ATR on Quality Control Check Report. (Apartments)

Quality Control Check Report. Stage: After Finishing Stage III (Apartments)

GULMOHAR RESIDENCY

Details of Additions & Alterations

Description		Direction	Owners & Developers :	Date:	Prepared By	Approved By	Scale :	Promoted by
WORKING PLAN-1660 Sft-BI TYPE		N	Modi Reality Mallapur LLP Project Name & Phase :	25.09.2020	Jayapradha	Soham Modi	N.T.S	Modi Properties Pvt Ltd
			Gulmohar Residency					Phone: +91-40-66335551

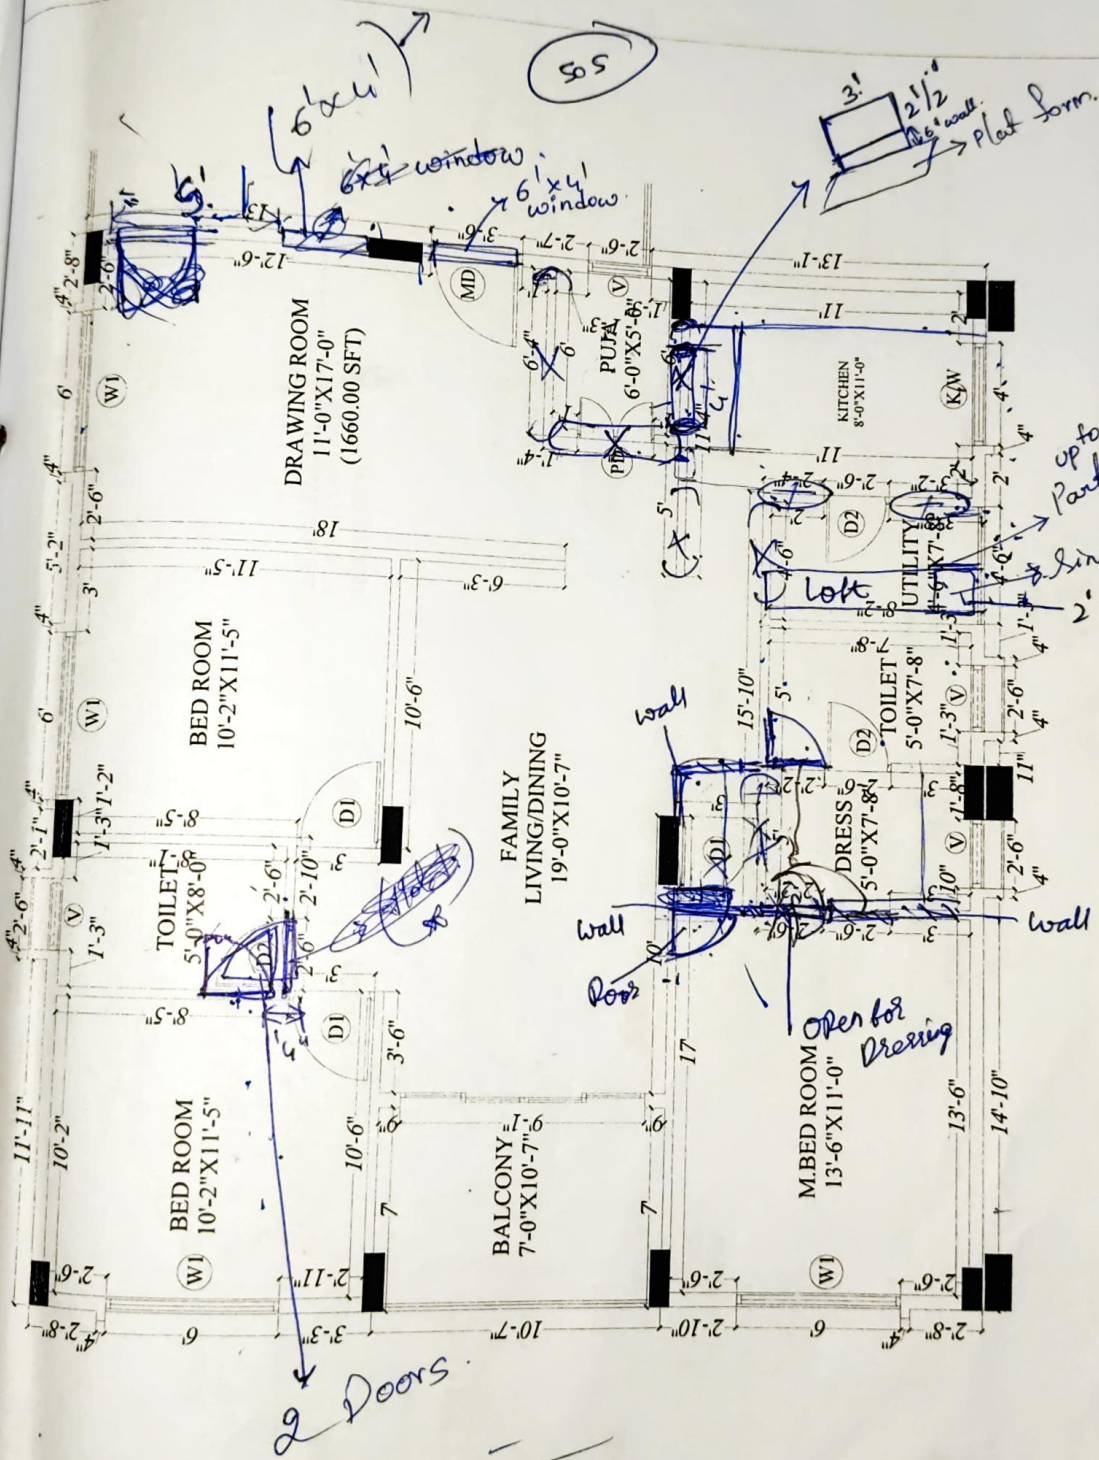
- ① ~~Main door position change~~ X Cancelled.
- ② Brick work changes to be done as per given plan

PLUMBING PLAN-1660 Sq Ft (B1-TYPE)

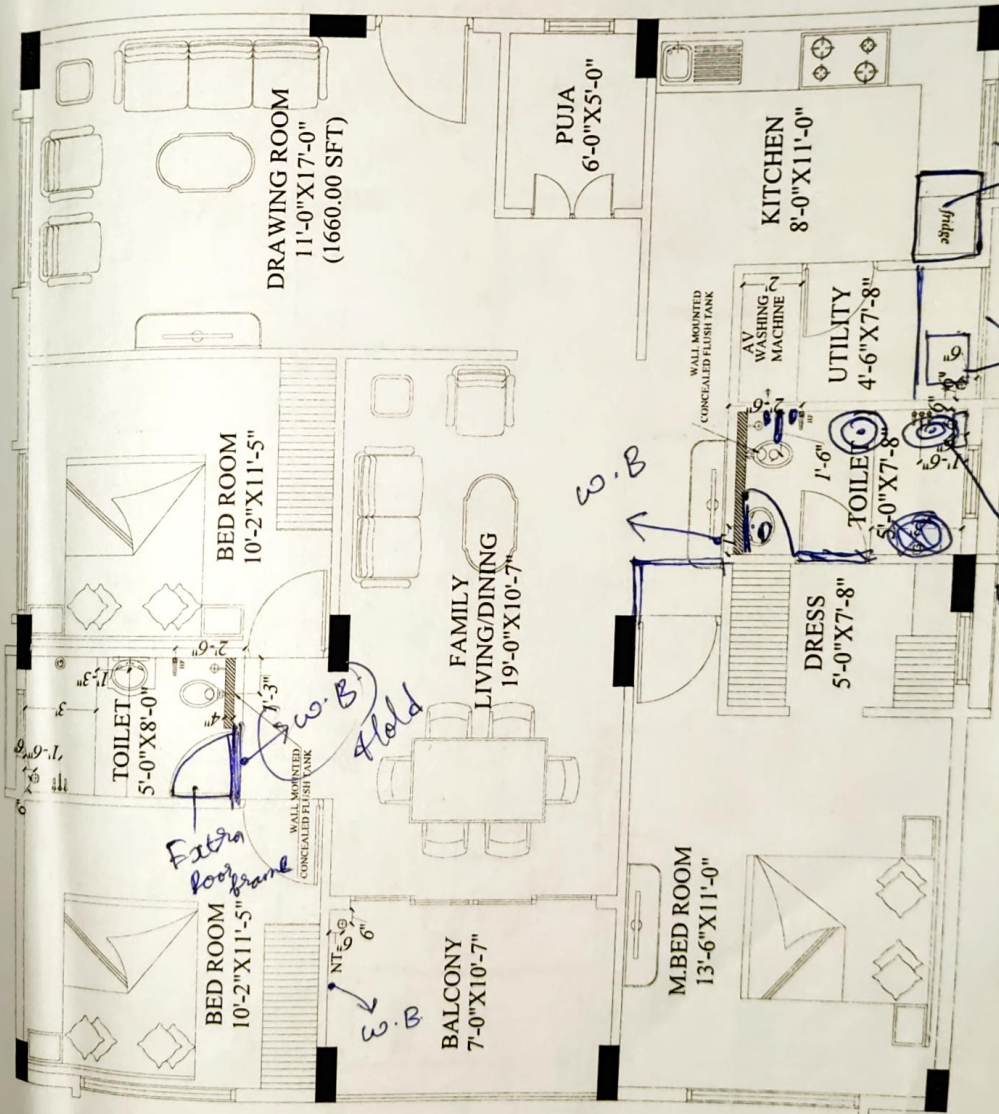
② changes to be done as per given plan.

ELECTRICAL PLAN -B1 TYPE-1660 sft	Description	Direction N 	Owners & Developers :		Date :	Promoted by
			Modi Reality Mallapur LLP		Prepared By :	23.09.2020
			Project Name & Phase :		Approved By :	Jayapradha
			Gulmohar Residency		Scale :	Soham Modi
						N.T.S
						Phone:+91-40-66335551

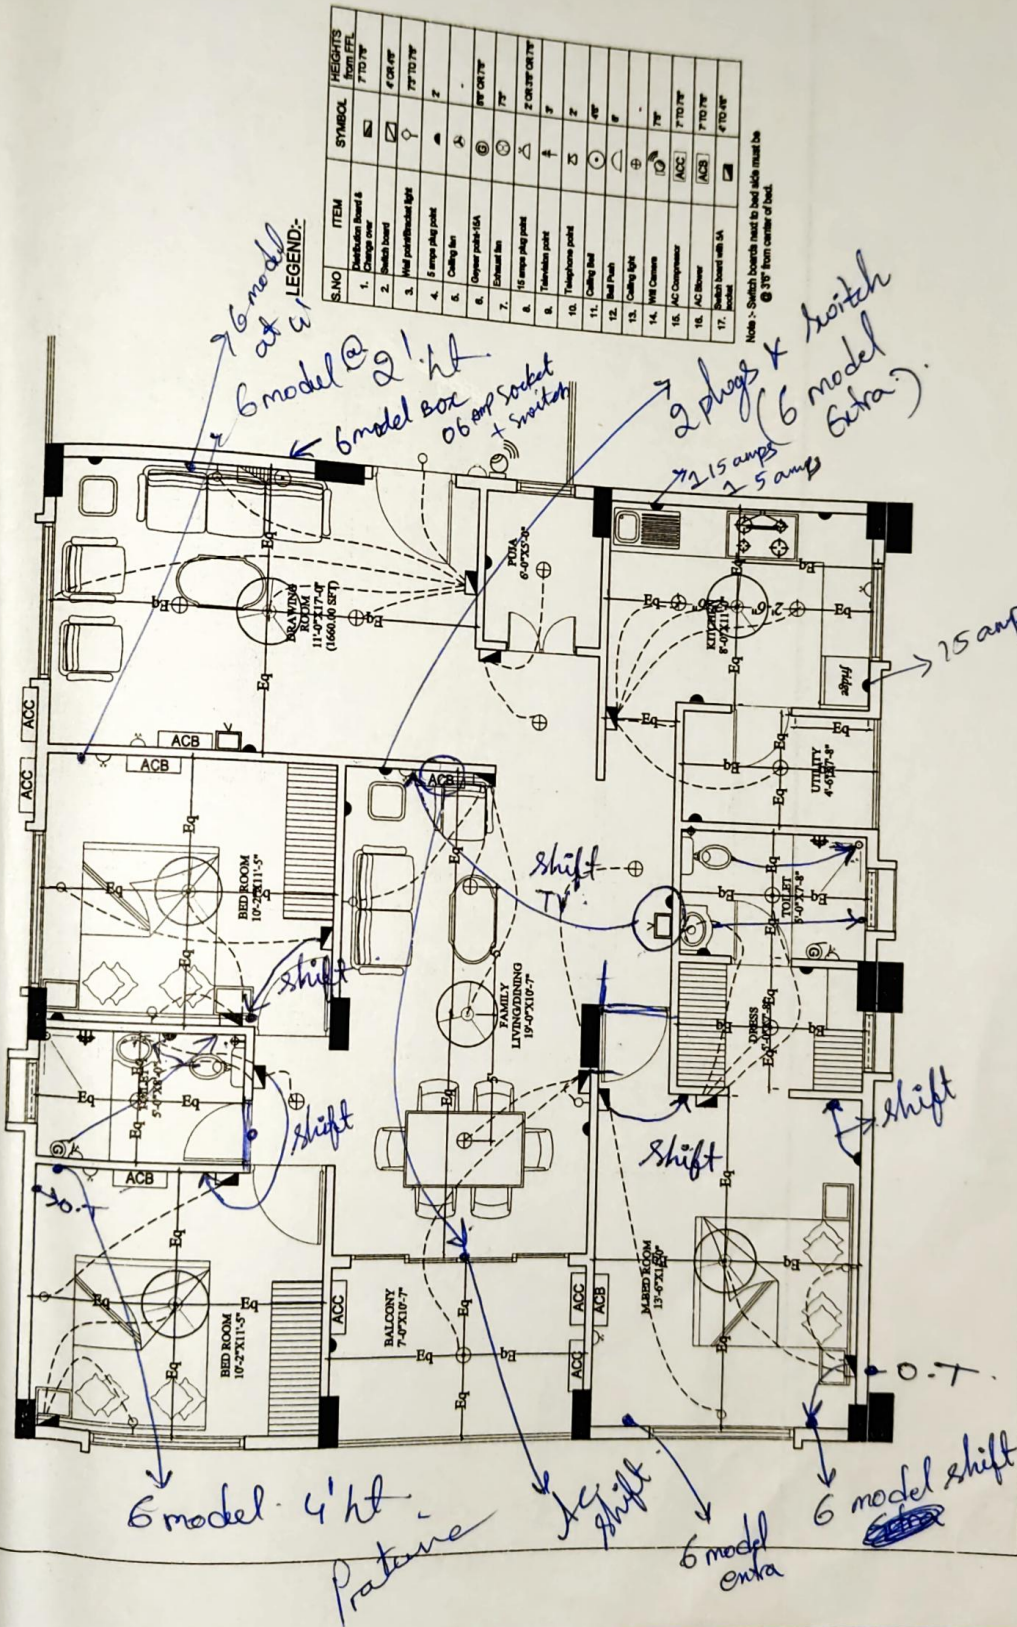
① changes to be done as per given plan.
